## Office Action Summary

10/642,835

***Claim Rejections - 35 USC § 103***

Fig. 1

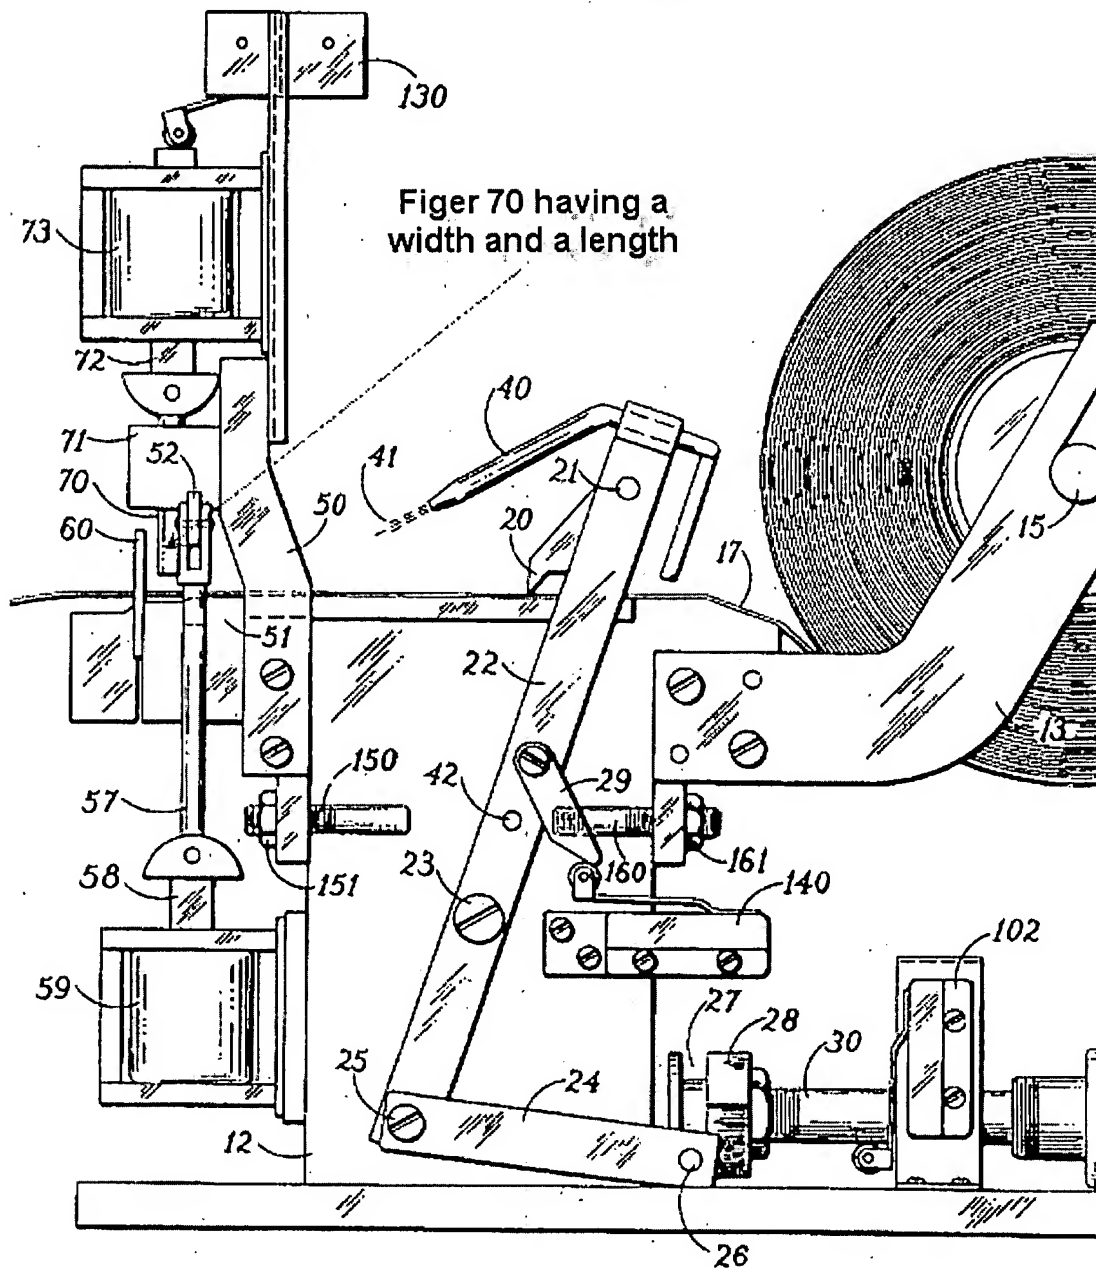
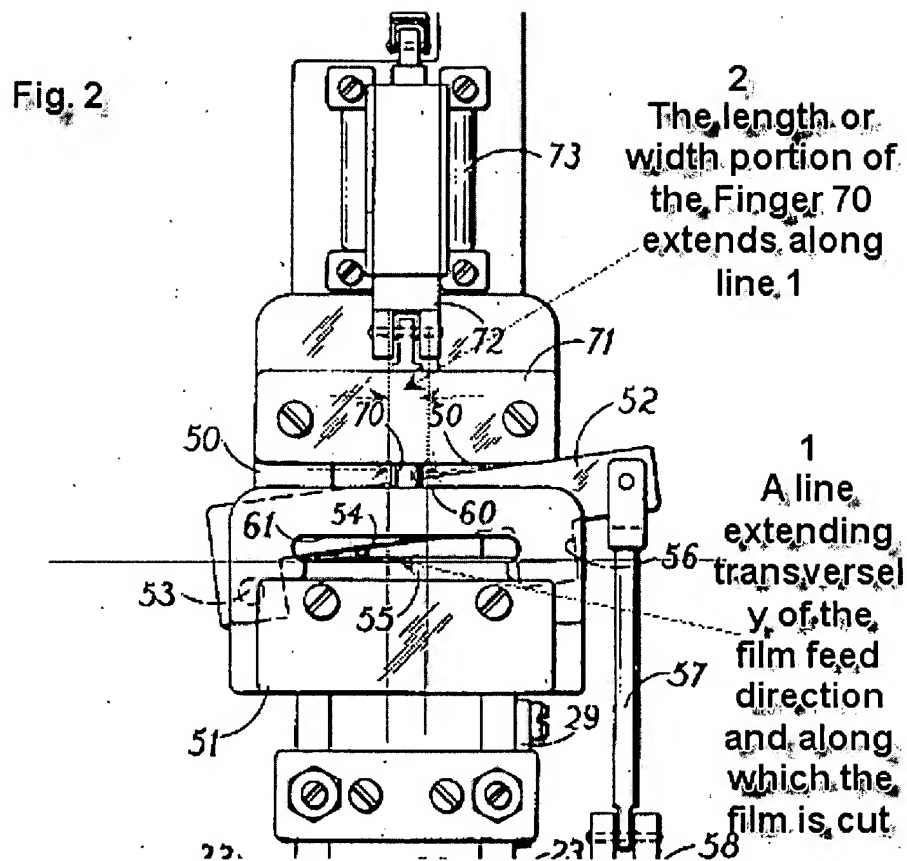
Applicant's argument that neither Price nor Oakes teaches or suggests that the film is clamped "along the length of a transverse line on which it is being cut" is not persuasive. Firstly claim 1 merely recites, "the film is clamped by the film holder, along the length of the line extending transversely of the film feed direction and along which the film is severed by the trimming device." See lines 11-13 in claim 1. It should be noted that the clamp holder or finger 70 clamps the film on a line that has the same length as the width of the clamp holder 70. The line located distanced from the cutting edge of the blade or line 2. See Figs. 1-2 below. The cutting edge 55 of the trimming device cuts the film 17 along the length of a line 2, which extends transversely of the film feed direction. Line 2 is parallel to the line that the film holder clamps the film 17. It should be noted that the line at which the film holder clamps the film is located along the length of the line 2.

In an alternative interpretation of claim 1, line 2 could represent the line on which the film is clamped by the film holder and extending transversely of the film feed direction. It should be noted that the film is clamped along the length of the line 2. The film holder

clamps the blade at line 2 which is located along the line that film is severed by the trimming device. It should be noted that “along which the film is severed by the trimming device” is being read as independent from “along the length of a line extending transversely of the film feed direction” so that the location of severance need not be on the same location as where the film is clamped. Therefore, the film is clamped along the length of the line extending transversely of the film feed direction and along the line that the film is cut.

Applicant's argument that the finger 70 is spaced apart from the knife 52 and does not clamp the film 17 at the cutting line is not persuasive. Firstly, claim 1 and other claims in the instant application do not call for the film to be clamped at the cutting line. Secondly, claim 1 calls for the film to be clamped along the line that the film is cut. As stated above, the film holder 70 camps the film 17 at the line that extends along or parallel to the line that the film is cut by the knife 52. See Figs. 1-2 below.

Applicant's argument that the finger or film holder 70 only supports the film at a single point is not persuasive. As shown in Figs. 1-2, film holder 70 has a width portion extending transversely in the feed direction of the film. The width of the film holder is spaced from trimming device 52 but extends along the line that the trimming device cuts the film. The width of the film holder could be considered as a large single point, but it has a length width that extends along a line transversely of the film feed direction.

Applicant also asserted that the term finger in Price reference would suggest that the finger 70 does not provide clamping along the length of a transverse line on which the film is cut. This is not true. As stated above, the finger 70 clearly shown to has a width portion that extends along a length of a transverse line which is also extended along the line that the film
